# UNITED STATES PATENT AND TRADEMARK OFFICE

APPLICATION NO.	FILING DATE	FIRST NAMED INVENTOR	ATTORNEY DOCKET NO.	CONFIRMATION NO.
10/519,116	08/10/2005	Mark Bigley	4990-106 US	9475
26817	7590	12/14/2006		
MATHEWS, SHEPHERD, MCKAY, & BRUNEAU, P.A. 29 THANET ROAD, SUITE 201 PRINCETON, NJ 08540			EXAMINER MENEZES, MARCUS	
			ART UNIT	PAPER NUMBER
			3677

<b>Office Action Summary</b>	Application No. 10/519,116	Applicant(s) BIGLEY ET AL.	
	Examiner Marcus Menezes	Art Unit 3677

## **DETAILED ACTION**

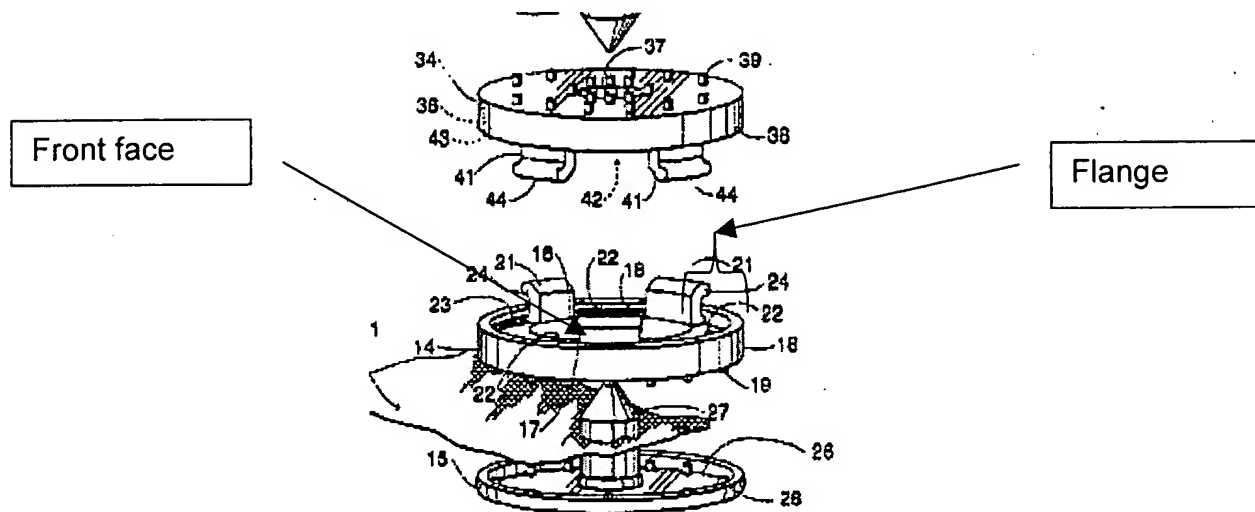
Lyle discloses a male stud (18) of a snap fastener comprising a flange with a means of attaching (28) said flange to fabric material (11); the flange having a cylindrical or annular shaped wall (22) extending axially therefrom, the wall comprising a plurality of circumferentially extending engaging portions (21), each engaging portion being separated from the next engaging portion by a circumferentially extending non

engaging portion. Said non engaging portion constitutes the part of the wall in between said engaging portions. (see below).

Lyle further discloses at least one engaging portion extending radially outwards. Also, said engaging portion is arcuate in shape. Further, said non-engaging portion comprises of a flat face and U-shaped recess.
